**BEAUFORT–PORT ROYAL
METROPOLITAN PLANNING COMMISSION**

AGENDA

Monday, December 20, 2021, 5:00 P.M.

Staff Report for Metropolitan Planning Commission

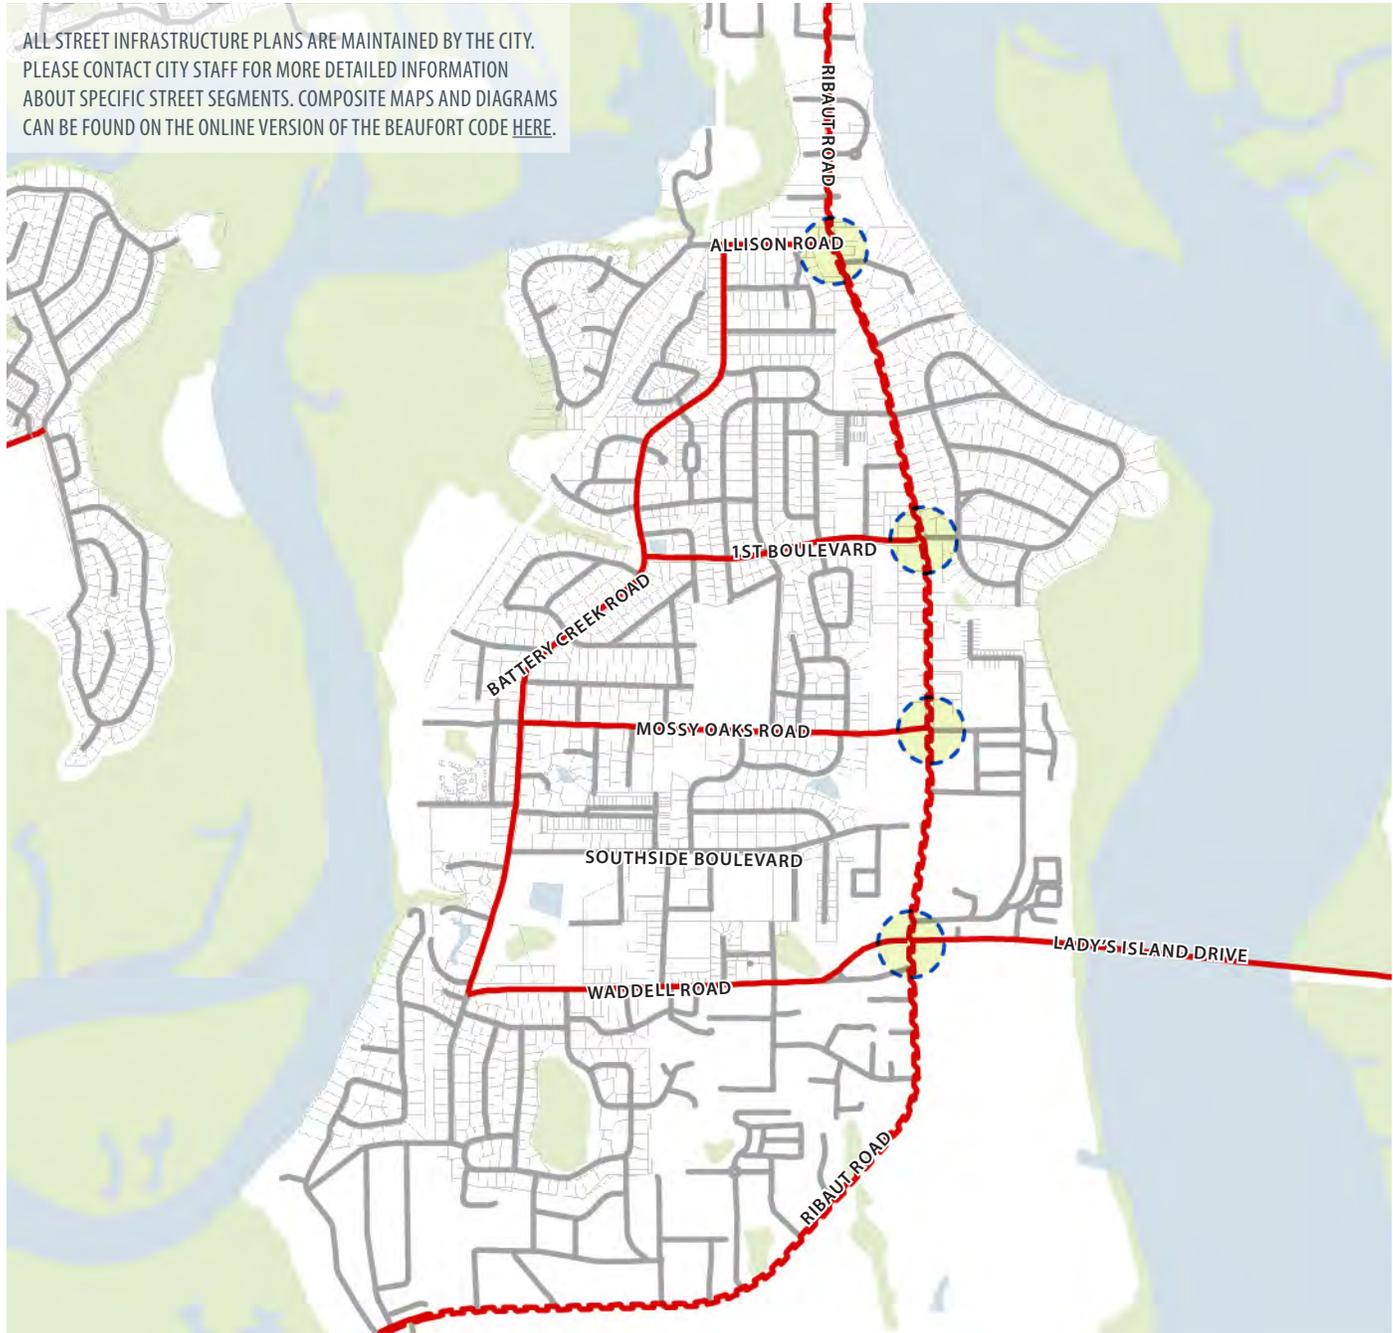
The applicant proposes the subdivision of 3 parcels totaling +/-11.95 acres and the extension and improvements of two existing roads. The Sketch Plan and narrative propose a Parcel ‘A’ that will contain a +/- 4,800 s.f. daycare facility and +/- 100 BMH surface parking spaces being relocated from proposed Parcel ‘B’. Parcel ‘B’ is proposed to contain approximately 52,000 s.f. of mixed-use development (retail, restaurant, office and medical) in three 2-story buildings fronting Allison Road and Ribaut Road, the associated parking as required by the Beaufort Code, and 39 residential units as permitted under the T5-UC zoning district. The sketch plan graphically depicts the location of proposed trees, sidewalks, alleys and on-street parking, and the project narrative notes that the streetscapes will include on-street parking, street trees, lighting and sidewalks.

The sketch plan meets Transect-based District Standards for Development as identified in Section 2.4.1. It should be noted that the Sketch Plan meets the requirement of Footnote 8 of Section 2.4.1.D.1, which requires 2-story buildings within 250 feet of significant intersections.

The Sketch Plan meets the requirements of Section 2.5.1.A.1.a by proposing buildings that are arranged to break up the site into smaller blocks defined by streets and pedestrian walkways.

The Allison Road and Ribaut Road intersection is designated a significant intersection per Beaufort Code Appendix C.3.2. (Attachment A). The proposed mixed-use buildings on the Sketch Plan meet the Section 2.6.3 two-story height requirements for buildings in the T5-UC district and within 250 feet of a designated significant intersection.

All proposed development depicted on the Sketch Plan is permitted by right, or conditionally, with the exception of proposed residential units 37, 38 and 39. These lots appear to be new single-family residential units, and no new single family dwelling units are allowed in the T5-UC District. A portion of Parcel 'B' is currently zoned T3-S and depicted on the Sketch Plan as future 2-3 Unit dwelling or Rowhome, neither of which is permitted in the T3-S district. Future Design Review submittals shall meet all requirements of Section 3.2 Table of Permitted Uses.

The Sketch Plan application does not identify the proposed street sections. Future Design Review submittals shall include street sections for Oak Haven Street and Myrtle Street that meet the requirements of Beaufort Code Appendix C: Street Infrastructure Plans.

1. Future design review submittals shall incorporate any traffic mitigation measures identified in the forthcoming Traffic Impact Analysis.
2. Future design review submittals shall include street sections for Oak Haven Street and Myrtle Street that meet the requirements of Beaufort Code Appendix C: Street Infrastructure Plans.
3. Future design review submittals shall meet the two-story building height requirements of Section 2.6.3 for all buildings within 250 feet of the significant intersection of Allison Road and Ribaut Road.

Recommendation: Sketch Plan approval with noted conditions
